East Midlands Gateway Phase 2 (EMG2) Transport Review

on behalf of Protect Diseworth

Railton TPC Ltd

Railton TPC Ltd ref:	EMG2 C
Planning Inspectorate	Ref: DCO: BC0410001, MCO: TR0510002
Planning Authority	Ref: N/A
Date:	July 2026
Author:	[REDACTED]

Plan 1: Route to A453 through Diseworth

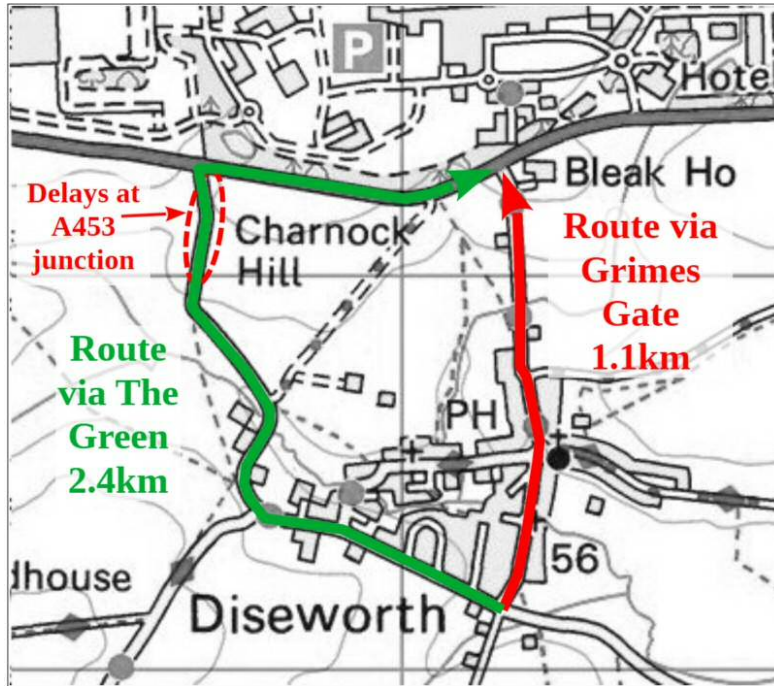
- 4.11 Drivers approaching from the Shepshed/Long Whatton area who are avoiding the Kegworth Bypass will be approaching Disewoth from the east. For these drivers, the route to the A453 via Grimes Gate is 1.3km shorter than the route via The Green as shown on the following plan:

- 4.12 The individual junction modelling suggests that drivers at The Green junction at the A453 would be subject to delays. The Grimes Gate/A453 junction, however, is shown not to be subject to any significant delays. The combined effect of a shorter travel distance and less delay when turning onto the A453 will lead to rat-running drivers using Grimes Gate through the Conservation Area that contains the primary school, the heritage centre, the church and sections of road without footways. The route through the village is of high sensitivity in transport environmental terms and would experience a major adverse impact in relation to pedestrian amenity, severance of community and safety of vulnerable highway users if the development leads to a significant increase in traffic on this link; an outcome that appears likely from the available evidence.

Graph 1: Number of Flights affecting Landside Movement (week commencing 08 June 2026)

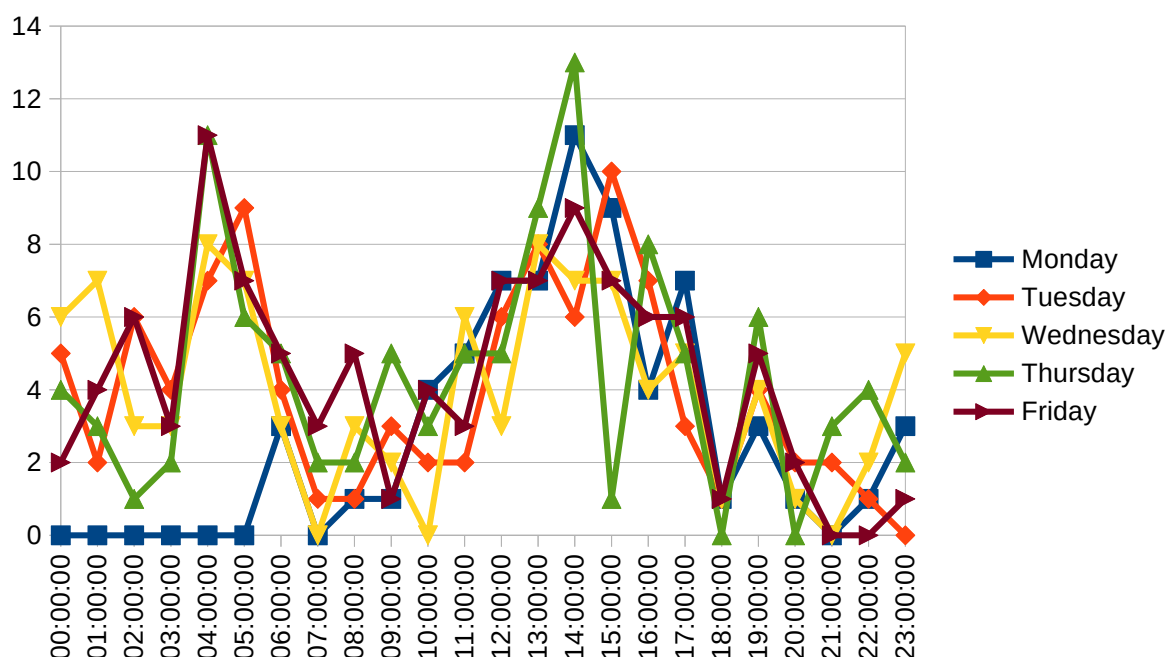
- 5.3 It is evident that the peak period when the airport generates landside movement is during the mid-afternoon. It is also evident that there is day-to-day variation in flight scheduling. This explains the experience of local residents who, before undertaking a

Graph 2: Daily Profile of Traffic Movements on A453 North of Finger Farm Roundabout (hour commencing)

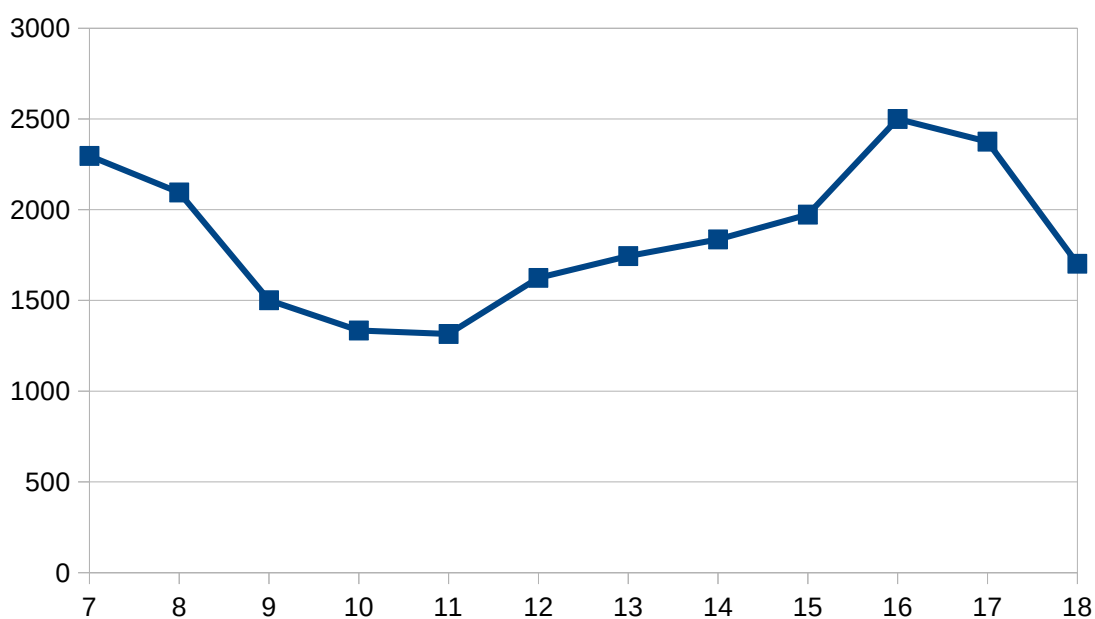
- 5.5 The 2-way vehicle flows are seen to be higher during the 16:00-17:00hrs period than during the 17:00-18:00hrs period. They are also shown to be the highest flows of the day. This is perhaps not surprising given the fact that traffic flows in the area will be significantly affected by landside airport movements and by the existing development at EMG1 that, like EMG2, has PM peak trip generation rates during the 16:00-17:00hrs period.
- 5.6 Since the applicant has not engaged with this issue, there is a risk that the worst case adverse impacts of the proposed development have not been assessed. If the mitigation strategy has not been based on the worst case impact, there is a risk that unacceptable impacts may arise that cannot be mitigated.

Appendix 4: Comparison of Observed and Modelled 2023 Turning Movements

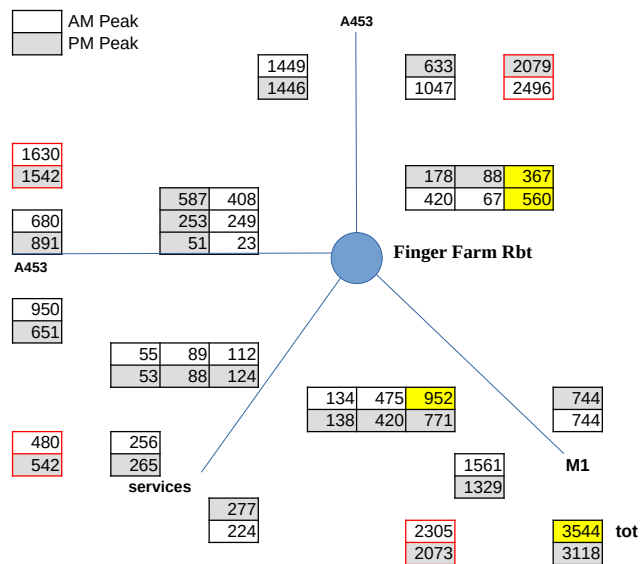
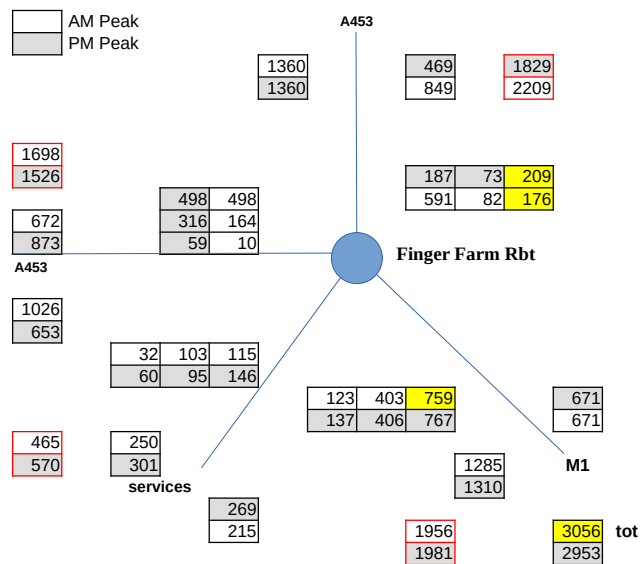
- 2.20 Appendix 1 of the Local Model Validation Report (LMVR)² contains turning count flow diagrams that compare observed 2023 turning movements with modelled 2023 turning movements. A summary of the data at the Finger Farm roundabout is attached as **Appendix 4** of this report.

- 2.21 Scrutiny of the turning movements reveals some significant differences between modelled and observed turning movements:
- In the AM peak, the southbound A453 to M1 modelled movement is 384 vehicles less than observed;

- In the PM peak the same modelled movement is 158 vehicles less than observed;
 - The northbound M1 to A453 north modelled movement in the AM peak is 193 vehicles less than observed.

2.22 These are significant differences³ and are likely to undermine the reliability of future year traffic modelling using the VISSIM model.
